ASB-993

## SERVICE BULLETIN

TH-27A/E Low TX Power

May 11, 1992

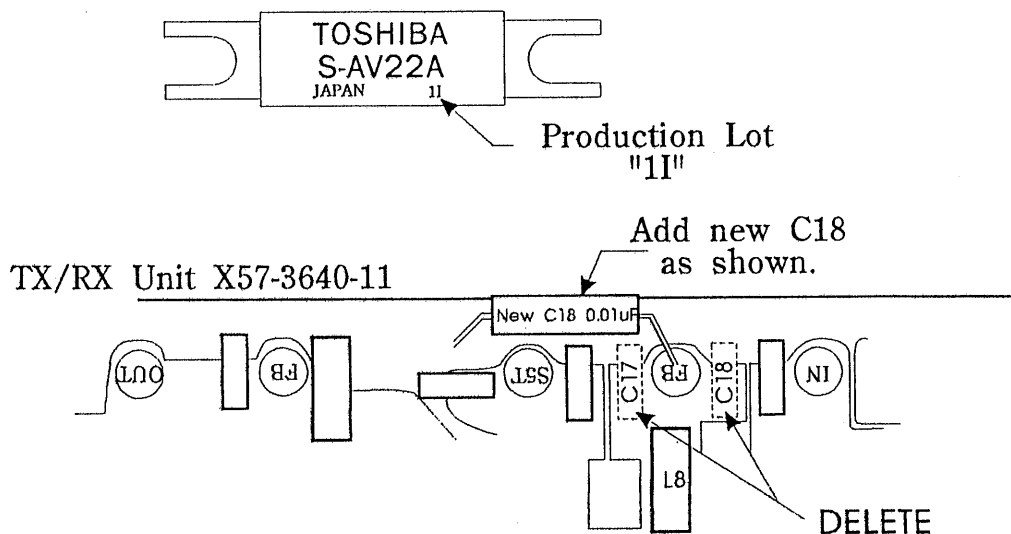
We have noticed some variation in the output power provided by Toshiba S-AV22A power modules with a production code of "11". Modules with this production code might exhibit low or no transmitter output power. This procedure will correct this problem.

1. Remove chip capacitors C17 and C18 from the TX-RX Unit (X57-3640-11.)

2. Install the new axial lead capacitor as shown in the accompanying diagram.

Note: Deleting C17 and C18 alone will not correct this symptom. The new C18 will be used to stabilize circuit performance. Deleting C17 alone will not cure the symptom.

0.01 uF axial lead capacitor ----- C91-0769-05
